CONDITION 12

PP/02/01324

Lots Road Power Station And Chelsea Creek

SUBMISSION OF DETAILS OF A SCHEME FOR THE TREATMENT OF CHELSEA CREEK PURSUANT TO CONDITION 12 OF PLANNING PERMISSION PP/02/01324 GRANTED BY THE SECRETARY OF STATE ON 30 JANUARY 2006.

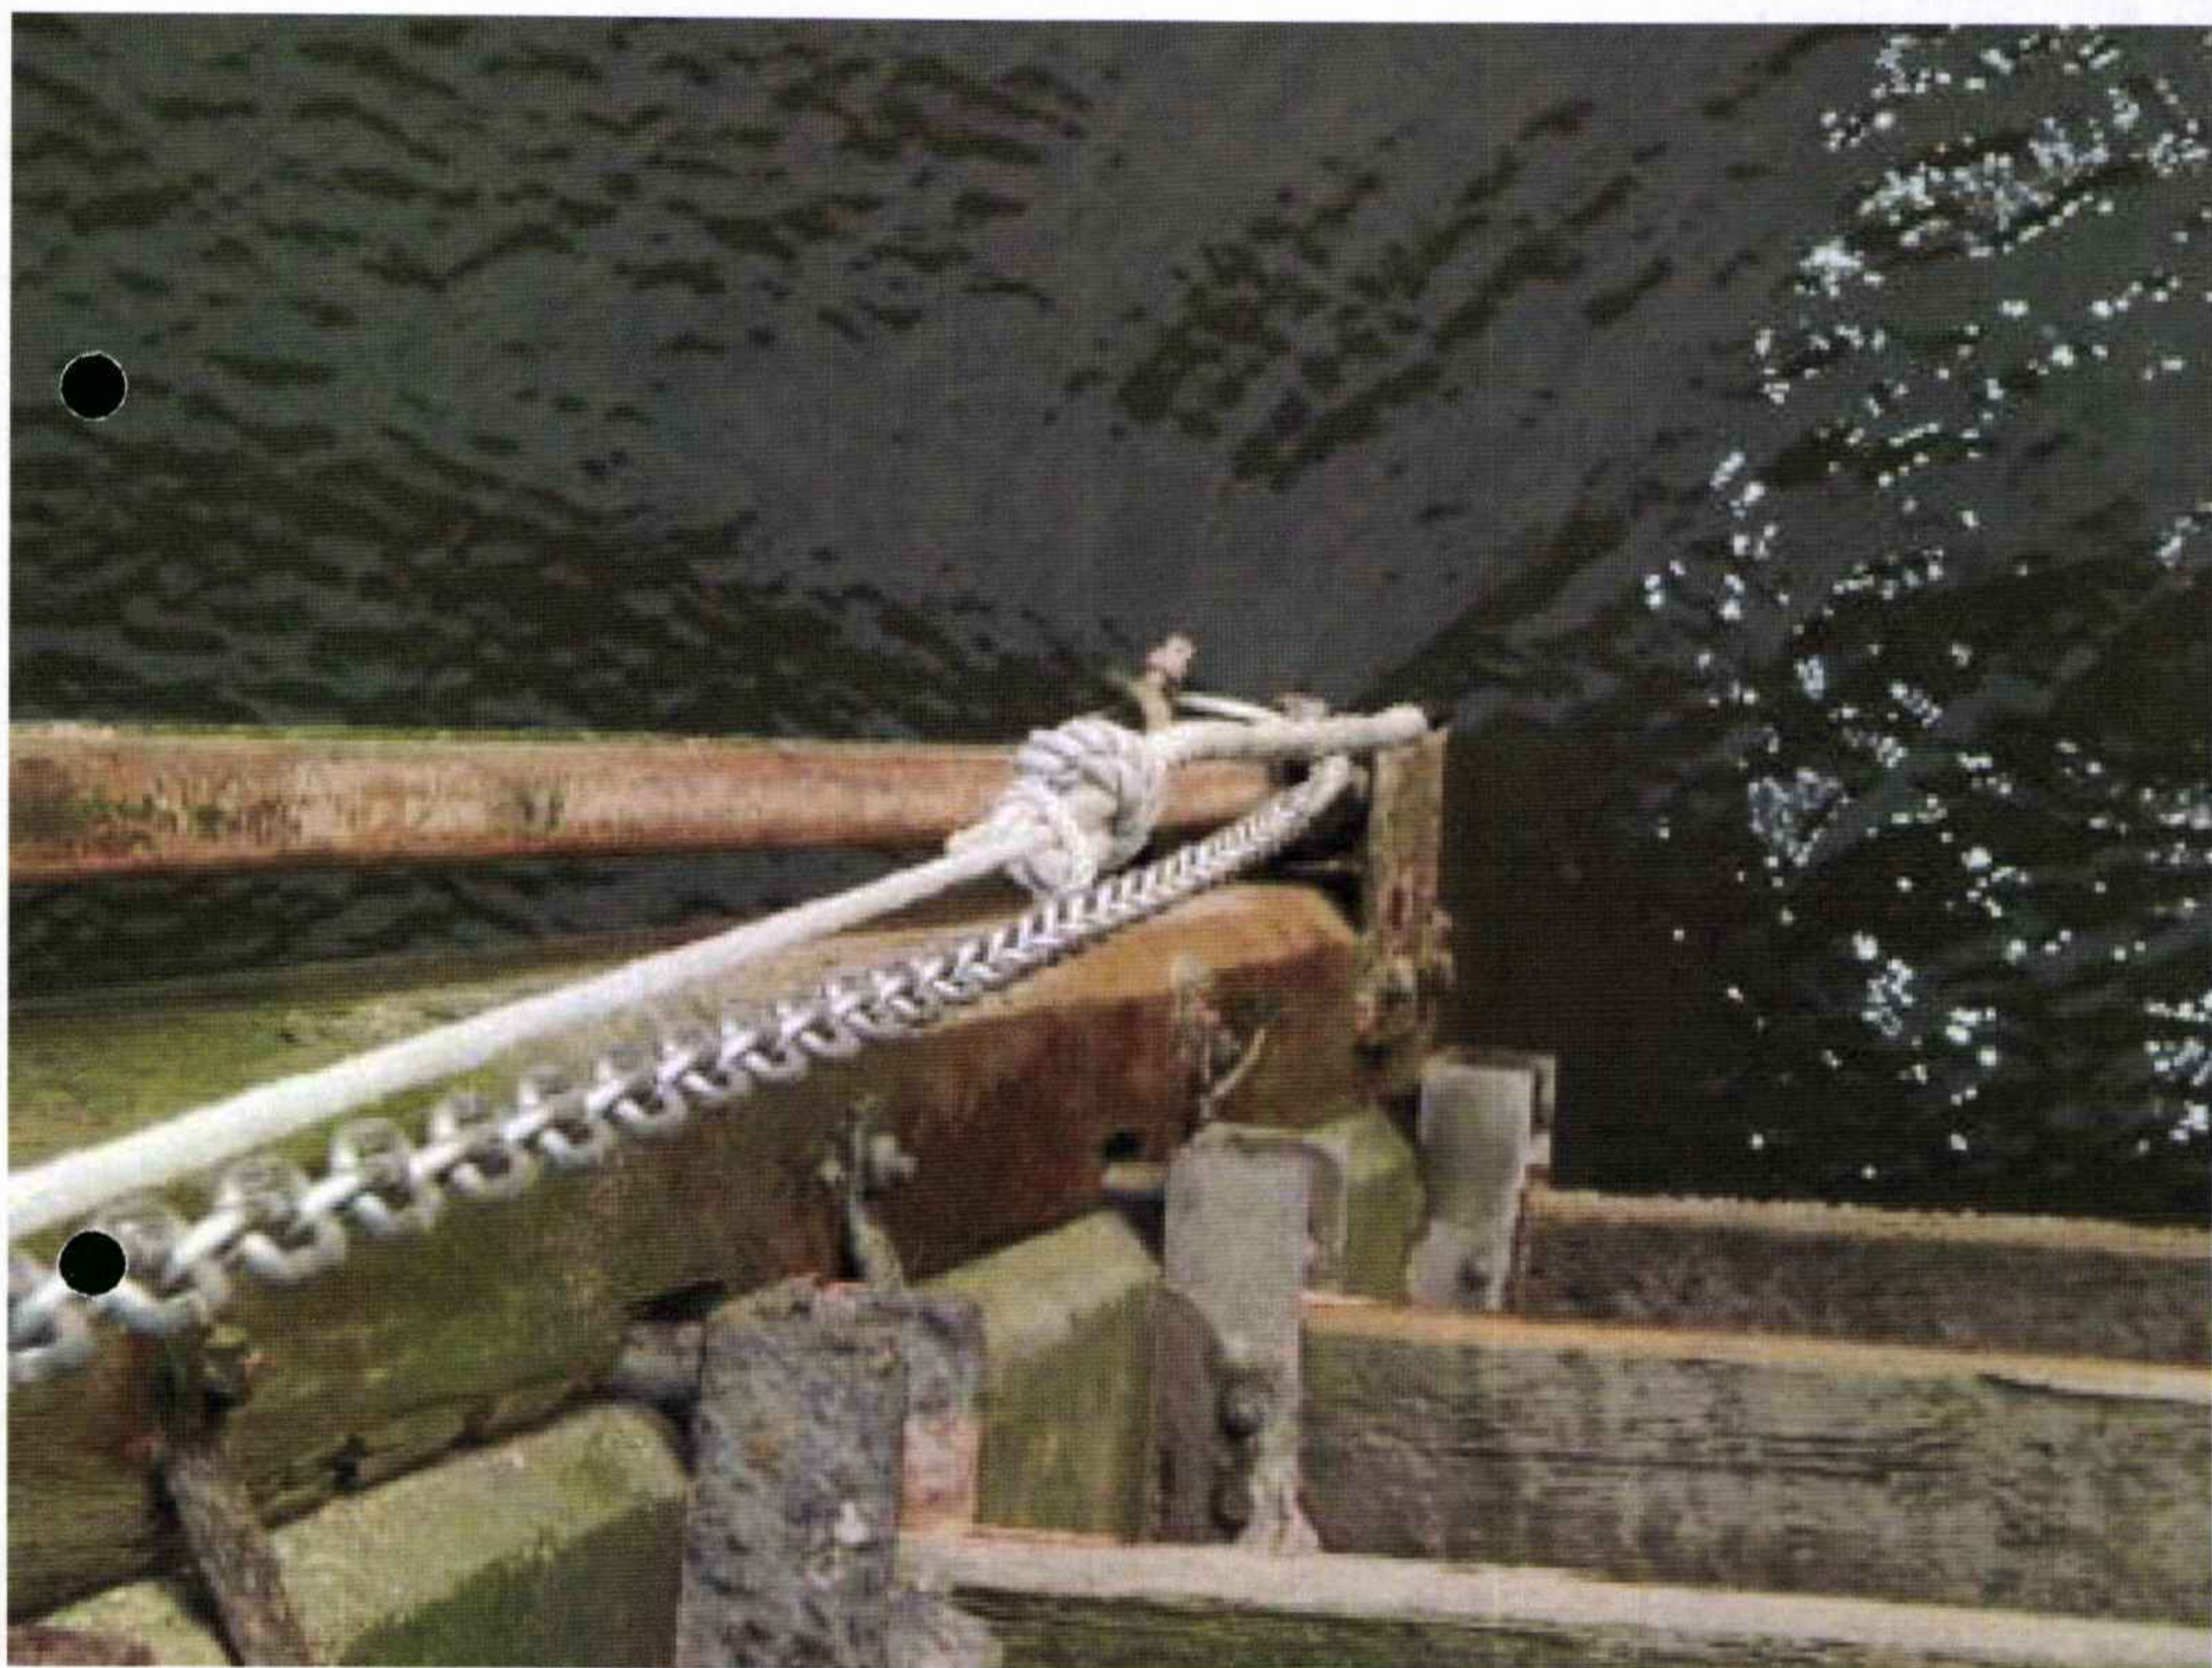
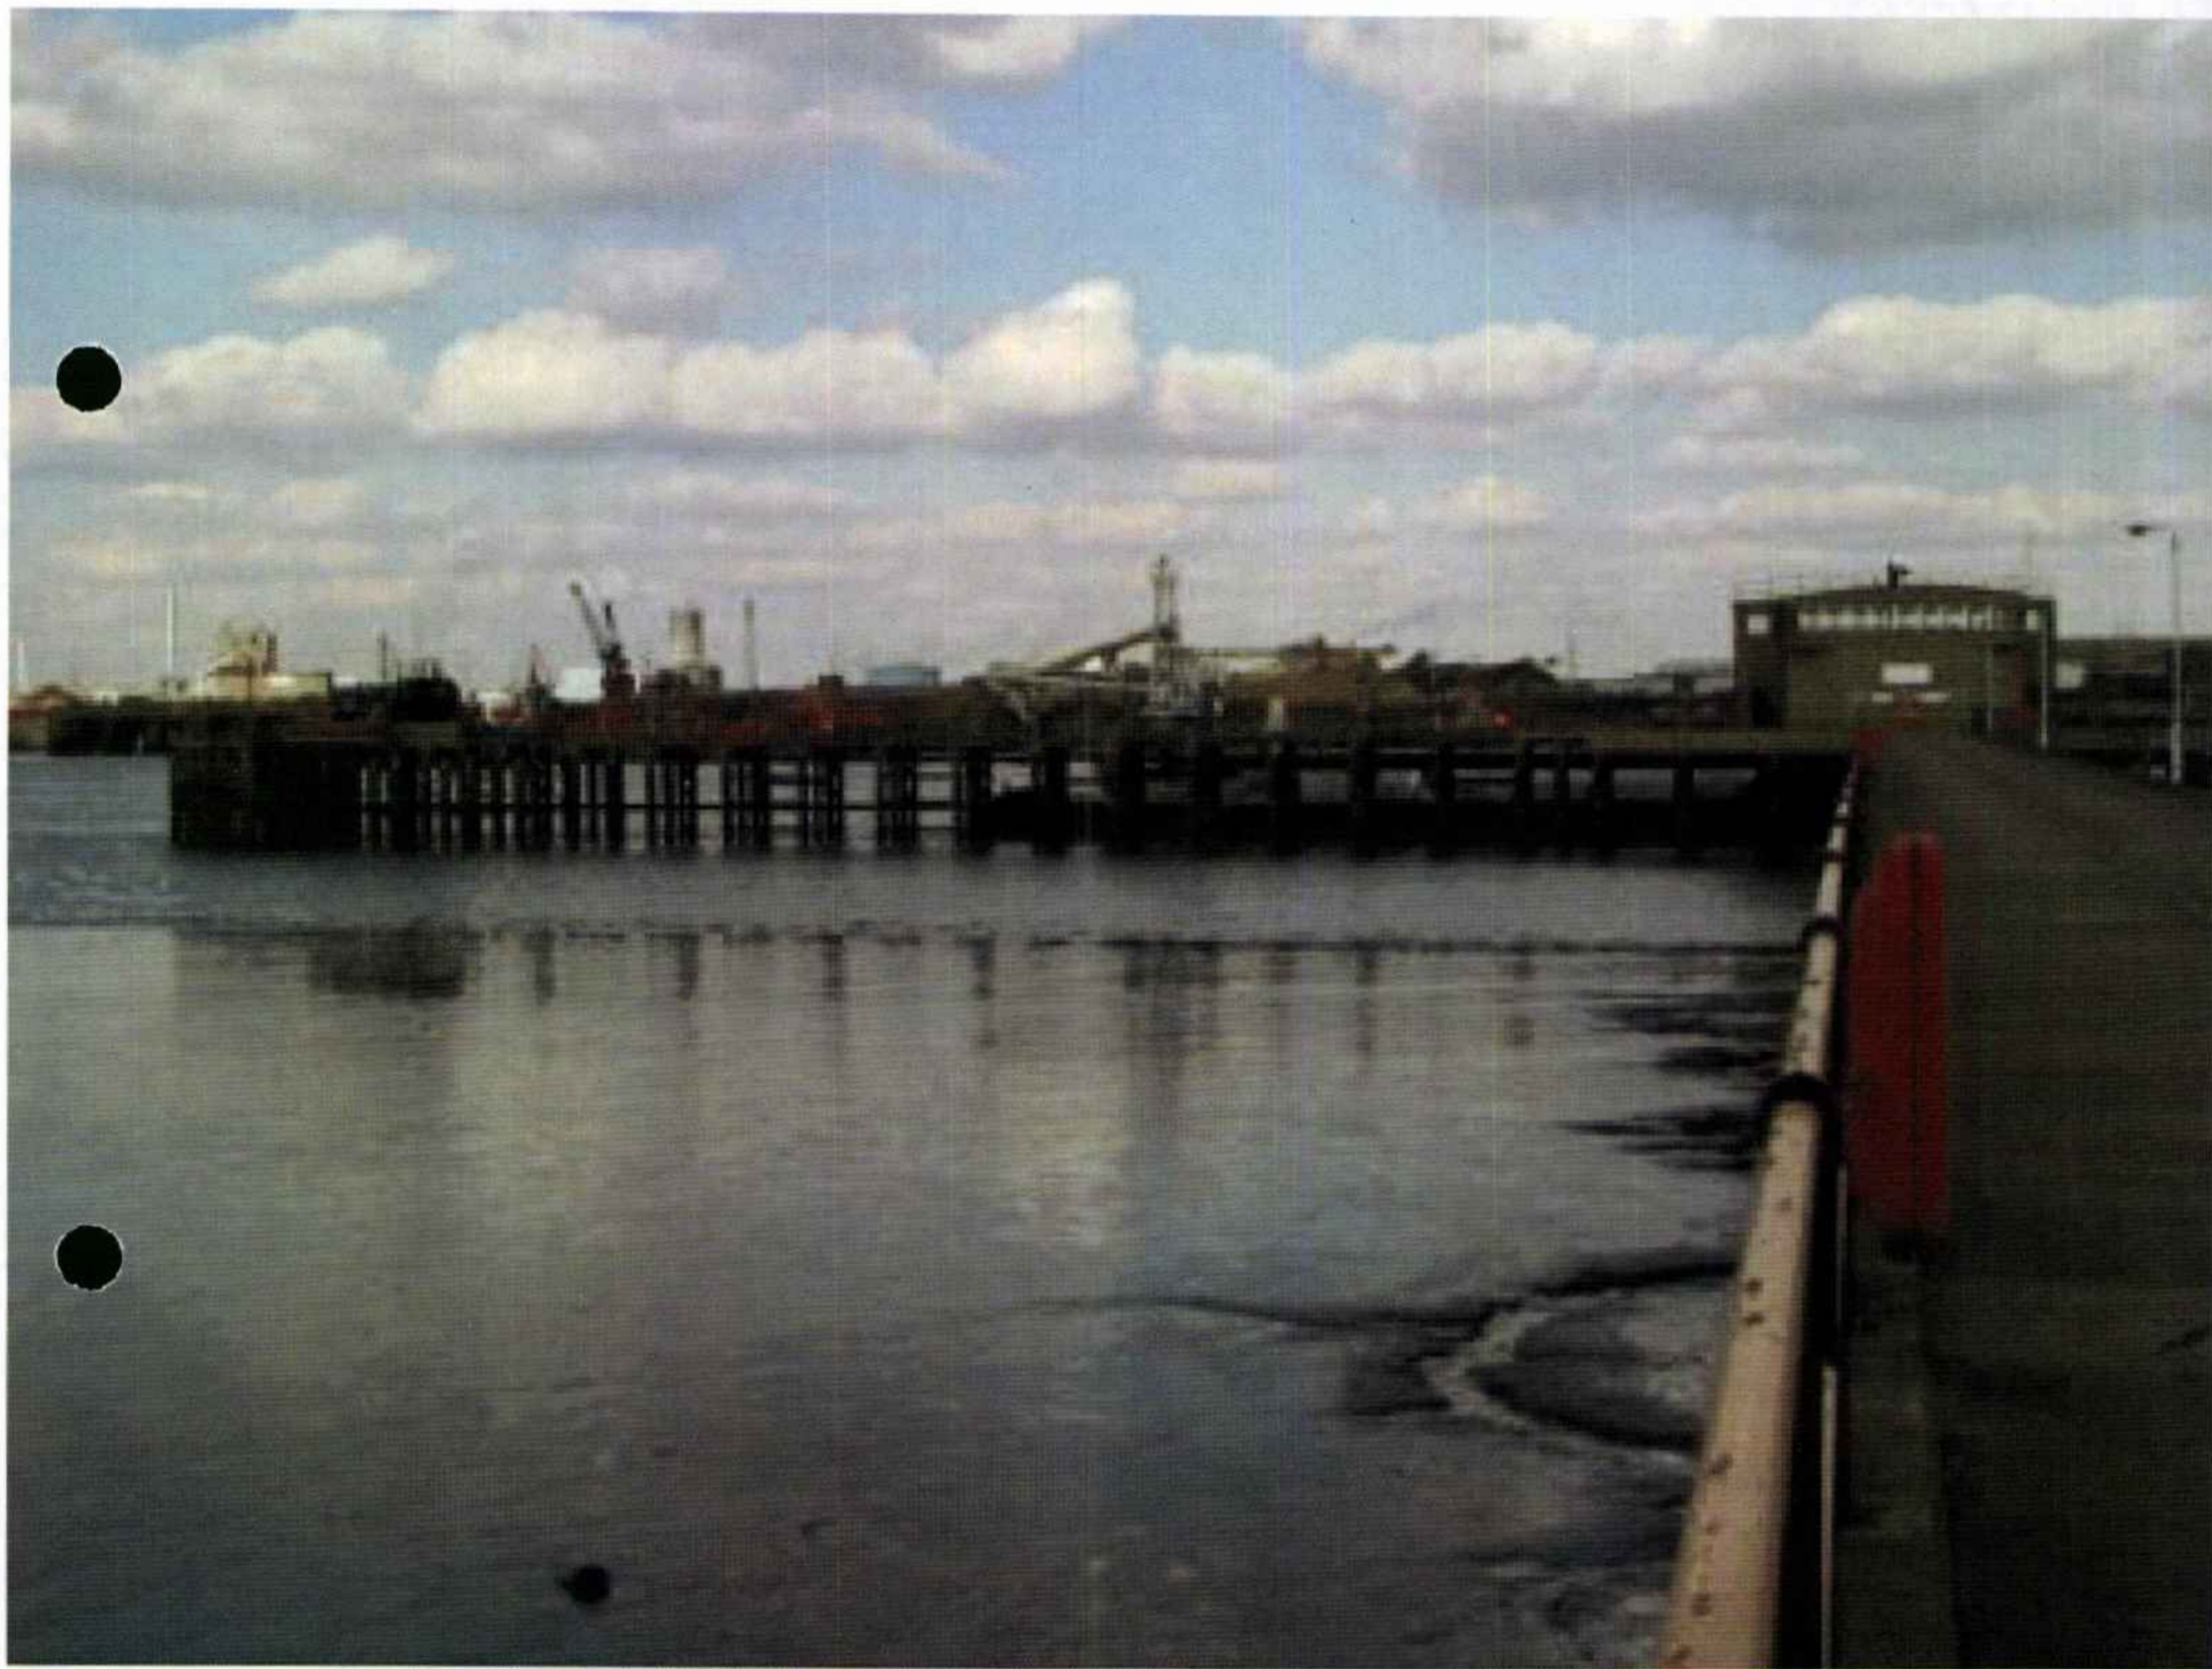
We request that drawings are submitted to show a boating landing pontoon to be accommodated within a gap in the terraces adjacent to the crescent shaped park. We are happy to advise on the design of the pontoon.

We recommend that either a rise and fall pontoon or provision for an access ladder with vertical fenders and vertical risers with rings. These are traditional method used for tidal waters. Please refer to photos attached to this letter.
